ADDENDUM NUMBER 1 ON INVITATION TO BID ITB18KO-129

TITLE: Beaty East – Clean, Point and Seal

ROOF & PENTHOUSE PLANS - BUILDINGS "A" & "B"

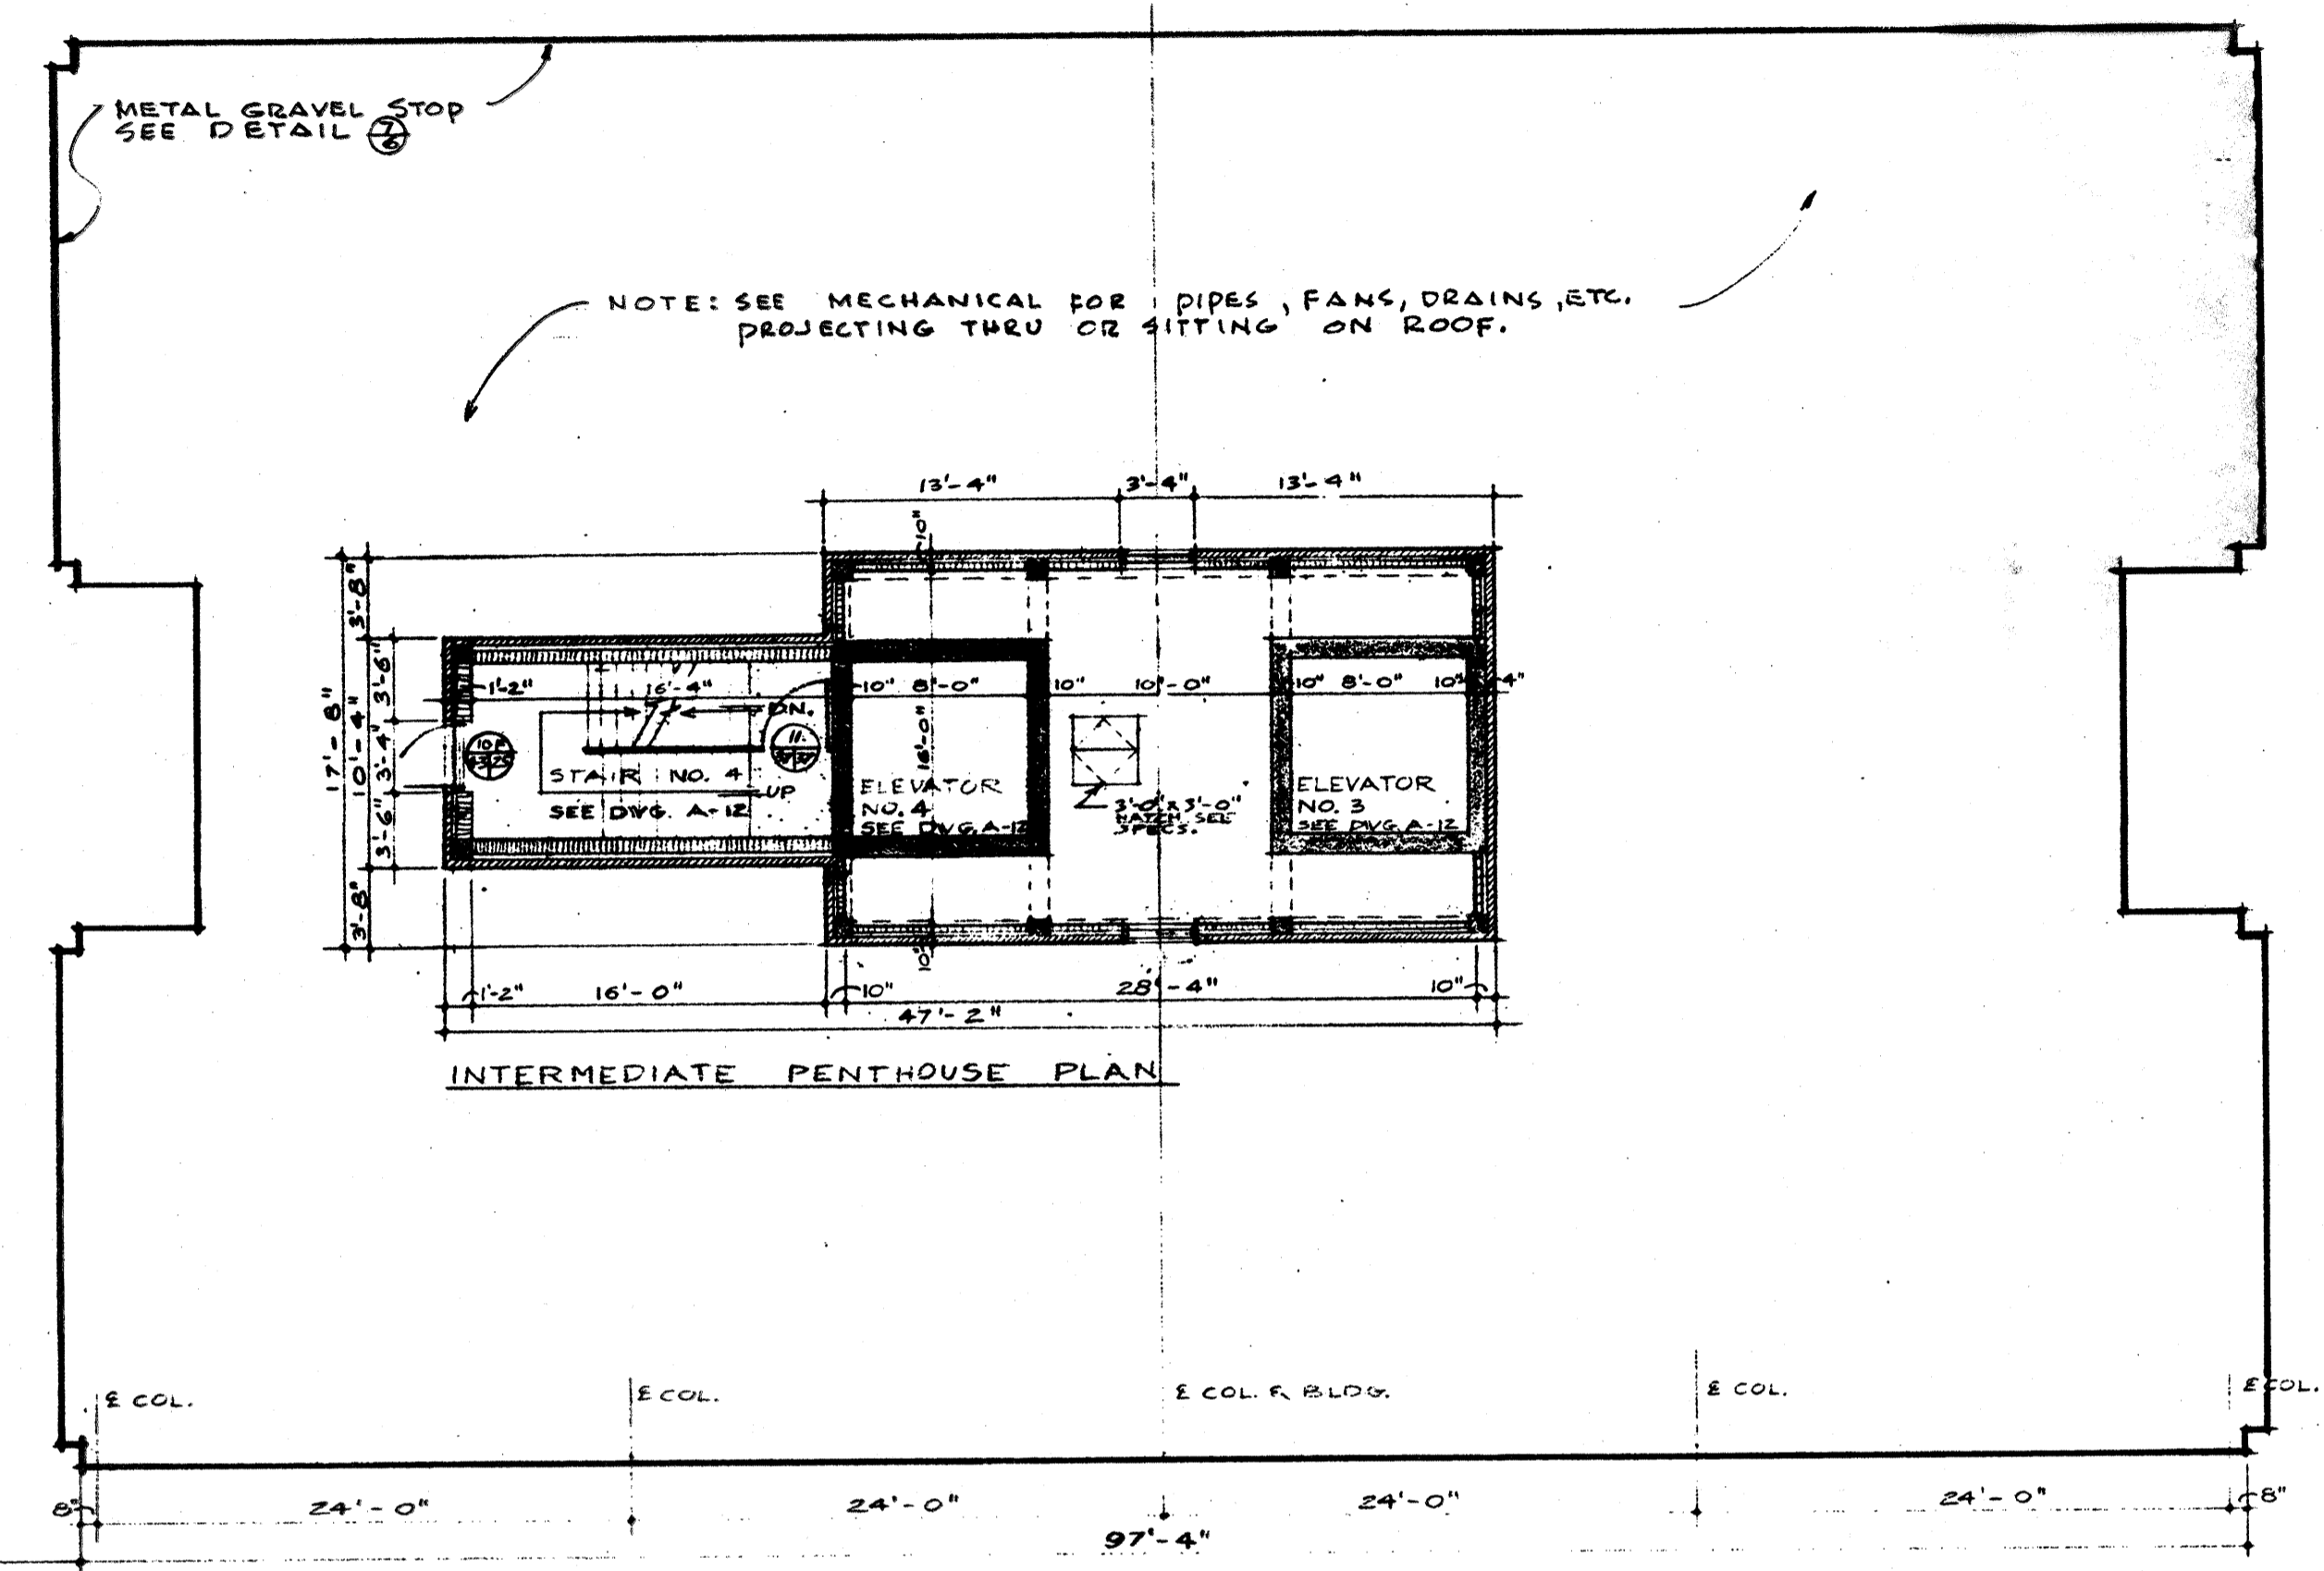
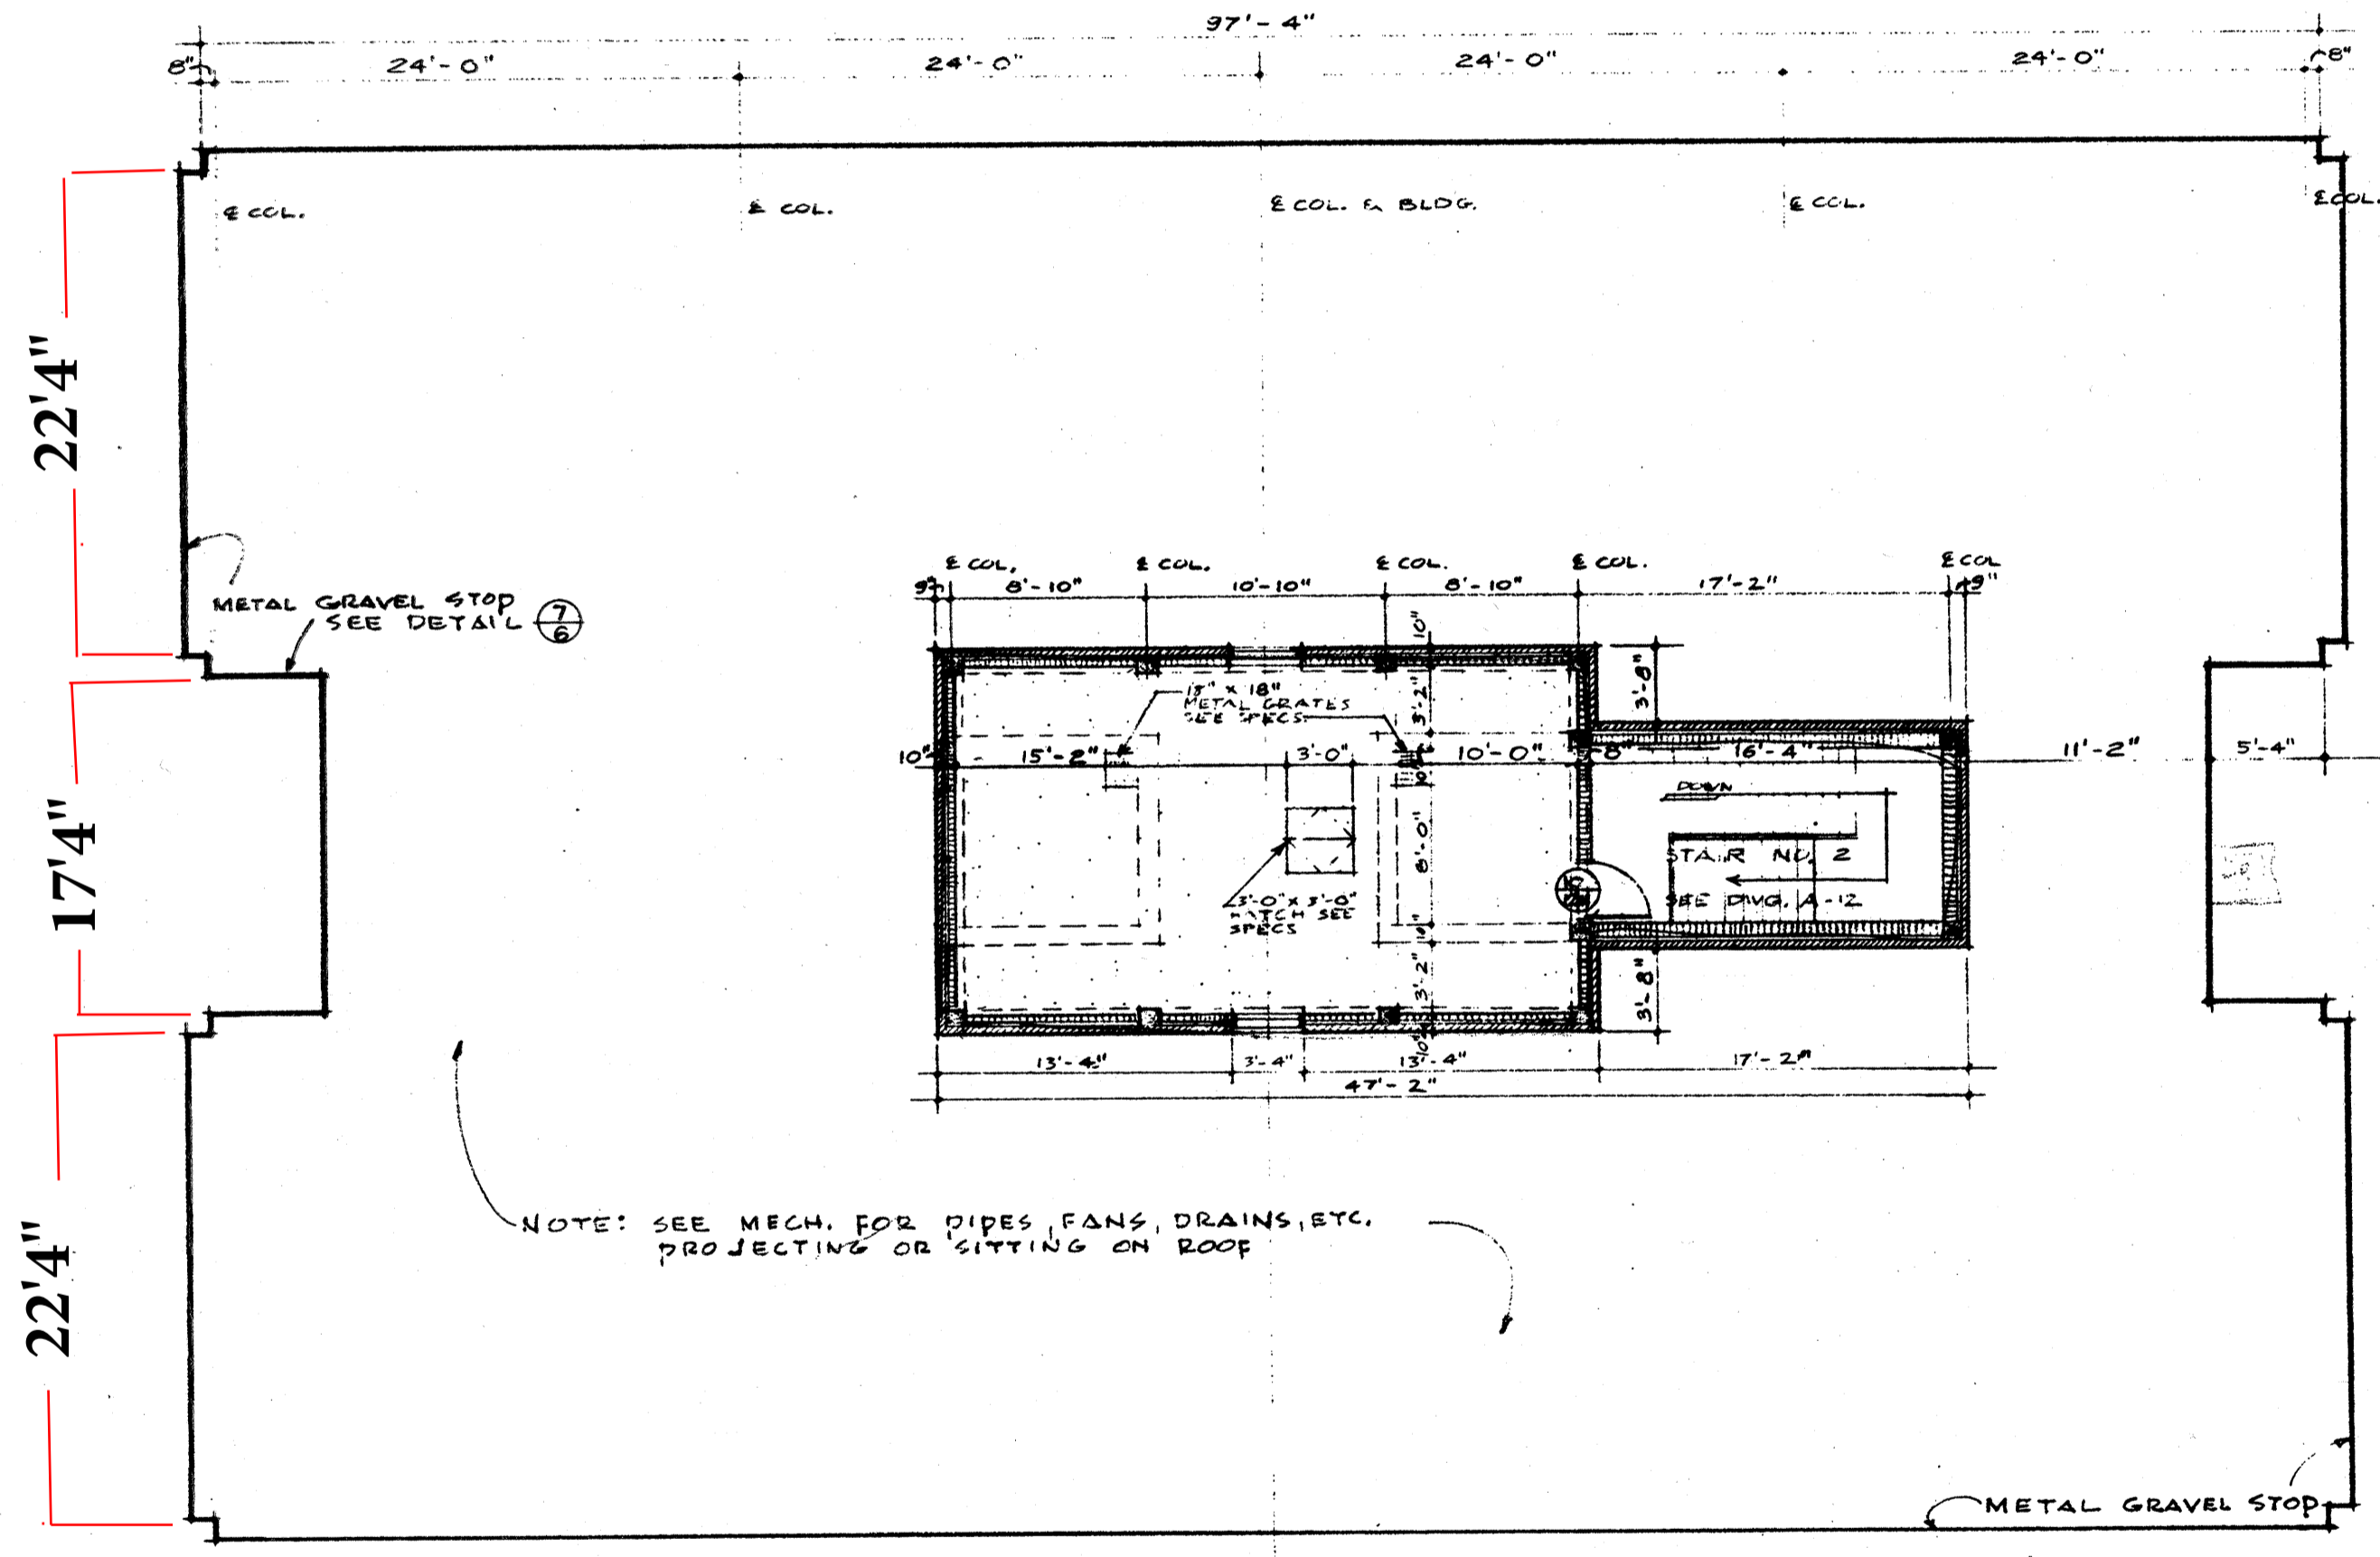
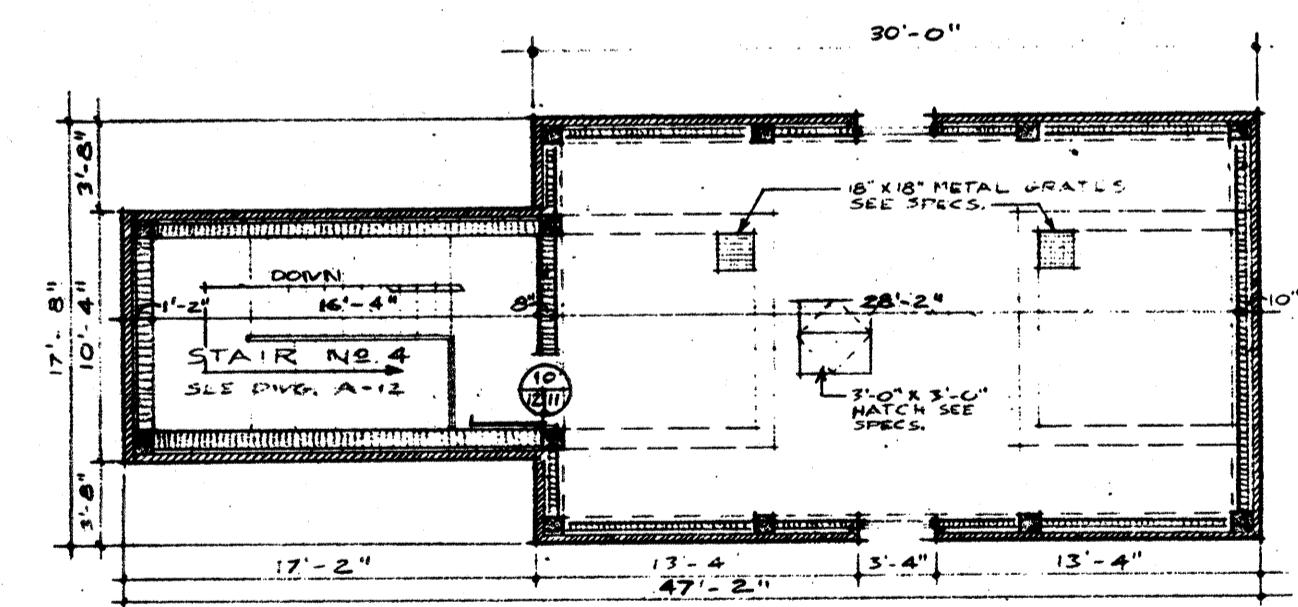
8. The brick portion on the top of the roof all the way up to the gravel stop is included in the specifications.

- Q8. Where will the tie off points for swing stages be and how will they be anchored?
- A8. Penthouse has anchoring points on all sides for anchoring. Tying off the swing stage will follow Manufacturer's instructions. Each person in the swing stage will have fall protection and lanyards on at all times.
